NOTICE TO MARINERS

No 07 (T) of 2020

Port of Southampton – Pilot Boarding and Disembarking Vessels – Non-compliant ‘Trap Door’ Arrangements

Fig 1: Non-compliant Arrangement

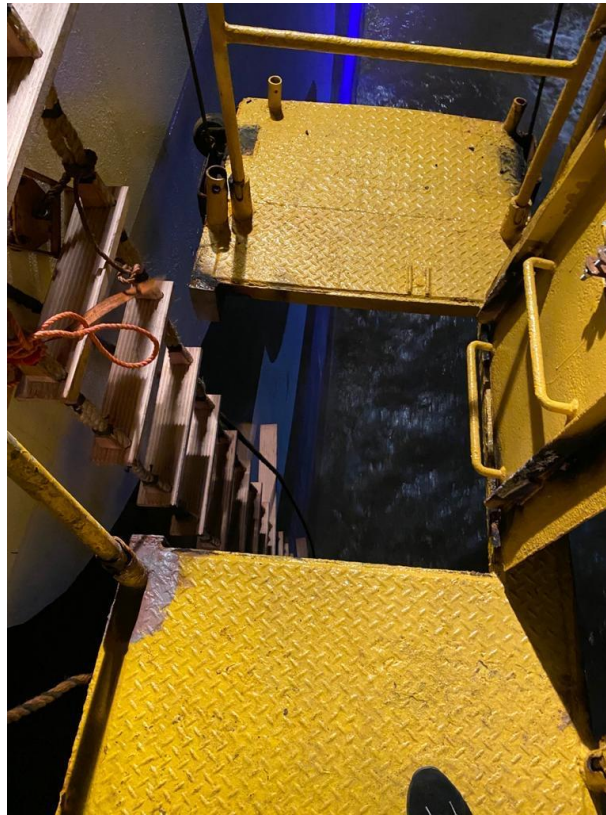
The arrangement at figure 1 is non-compliant because:

- The pilot ladder is not rigged to extend through the trapdoor and secured 1½ metres above the bottom platform (SOLAS 3.3.2.1). The method of securing the ladder to the underside of the platform shown in the figure is dangerous because the transition from the pilot ladder is done via an uneven step height.
- The horizontal cross member to which the pilot ladder is secured is a distraction from using the side ropes when transitioning onto the pilot ladder when disembarking.

- The pilot ladder steps cannot rest firmly against the ship's side, due to the nylon wheels attached on the inboard side of the bottom platform.
- The 'sloping ladder' is not securely attached to the hull.
